New proposals on split-runs for UNECE WLTP road load

ROAD LOAD SPLIT RUNS

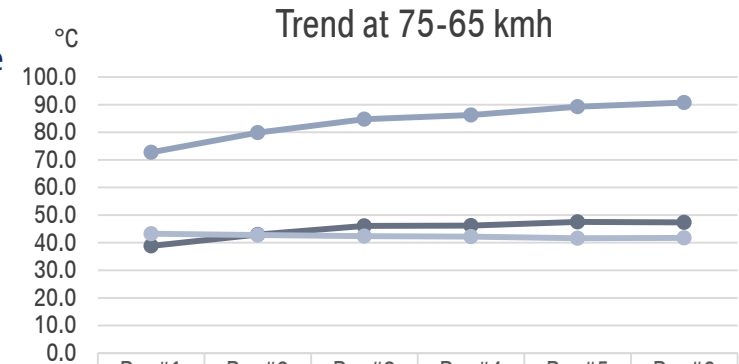
- Sequence (b) is closer at the initial sequence without splits, having complete runs prior to start a new run. Advantage: Statistical criterion can be checked and coast down can be stopped immediately after having fulfilled the criterion.
- But also sequence (a) can deliver correct results.
- Do we need a definition / decision, or should both options be possible?

Test data – assessment of gearbox temperature

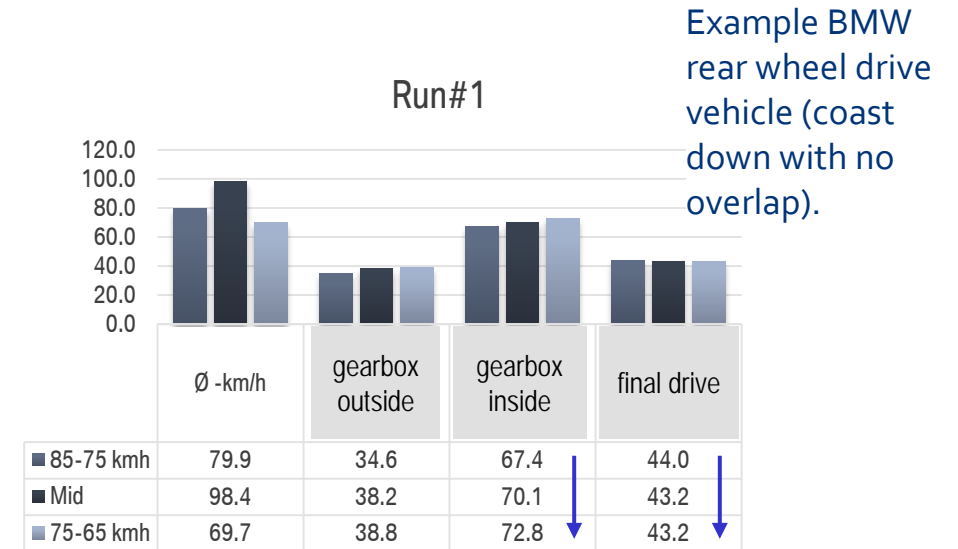
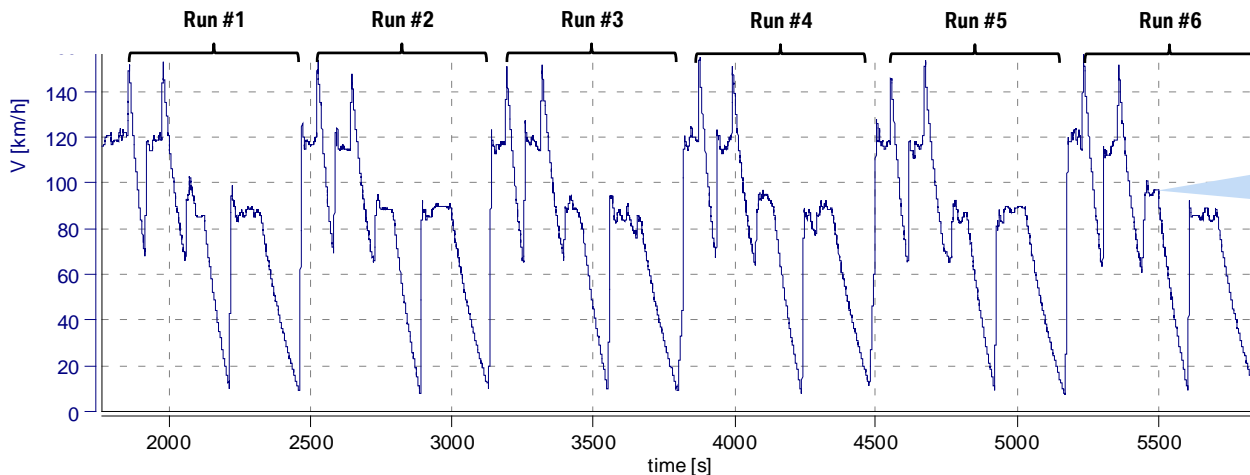
- Draft text:
 - (i) representative parameter: transmission oil temperature
- Example shows, that for gearbox temperature increased, for final drive decreased
 → no general rule possible! Tolerance does not work.
- Influence on coast down result not measureable if temperature changes in that magnitude take place.

velocity during split was slightly above reference speed.

temperature goes up.

temperature goes down at the same time.
